TAYLOR POINTE SUBDIVISION,

UNIT ONE

APPLICATION NUMBER 12 DATE December 20, 2007

DETAIL SITE PLAN

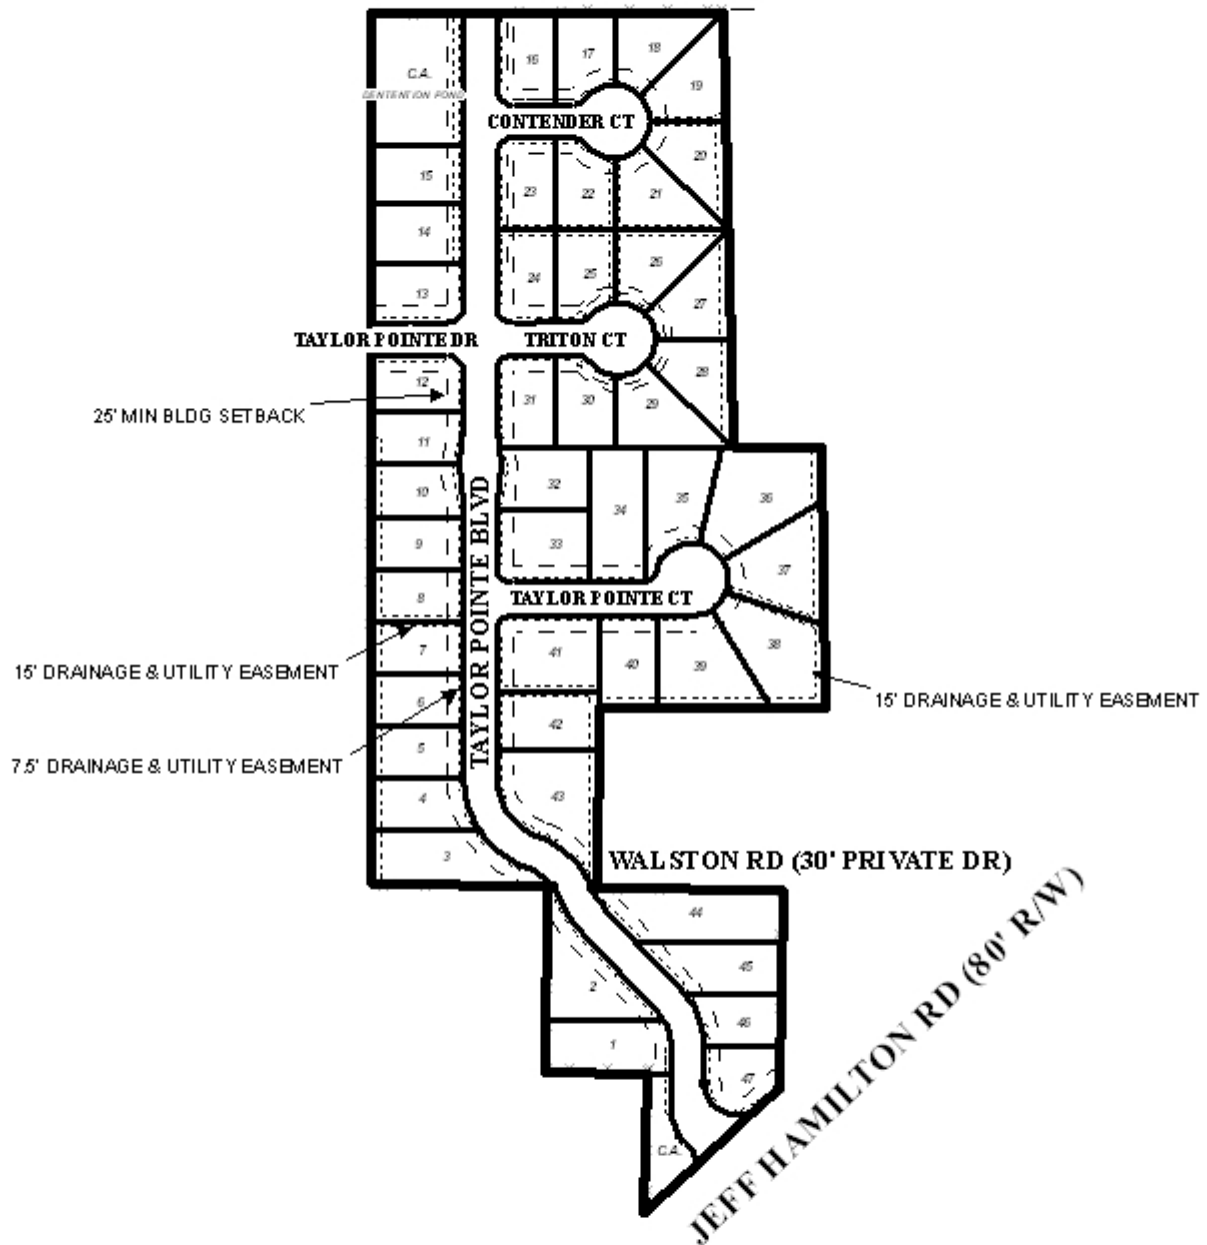
The applicant has constructed roads to allow a phased Unit One (47 lots); however, the subdivision was not signed due to a condition placed by the Commission requiring the provision of two traffic circles on each of the main streets, with size, location, and design to be determined by County Engineering. The applicant has submitted the preliminary plat illustrating only one traffic circle on the main street.

The site involves the creation of new streets which must be constructed and dedicated to County Engineering standards, including stubs to the North, and West. Most of these streets are short cul-de-sacs. The one main road is over 1200 feet long and very straight, and would therefore require calming devices; the only kind of calming device that the County will accept is a traffic circle. Based on the length of the street, curves in the first section, it is recommended that the main street feature one traffic circle as now proposed. Suitable location for this circle may be on Taylor Pointe Boulevard midpoint between Taylor Pointe Court and Triton Court; however, size, location, and design will ultimately be subject to County Engineering approval.

In addition, as a means of access management, a note should be placed on the final plat stating that Lot 47 is denied direct access to Jeff Hamilton Road, and since lots 12, 13, 16, 23, 24, 31, 33, and 41 are corner lots therefore, a note should be placed on the Final Plat limiting each lot to one curb cut each, with the size, design and location to be approved by County Engineering.

The plat illustrates three common areas, therefore, all common areas should be labeled and a note should be placed on the final plat stating that maintenance of common areas will be property owners' responsibility.

- 1) the provision of one traffic circle on Taylor Pointe Boulevard midpoint between Taylor Pointe Court and Triton Court, size, location, and design be approved by County Engineering;

- 2) the placement of a note on the Final Plat stating that Lot 47 is denied direct access to Jeff Hamilton Road;
- 3) the placement of a note on the Final Plat stating that lots 12, 13, 16, 23, 24, 31, 33, and 41 are corner lots and are limited to one curb cut each, with the size, design and location to be approved by County Engineering;

- 4) the labeling of all common areas and the placement of a note on the final plat stating that maintenance of common areas will be property owners' responsibility;
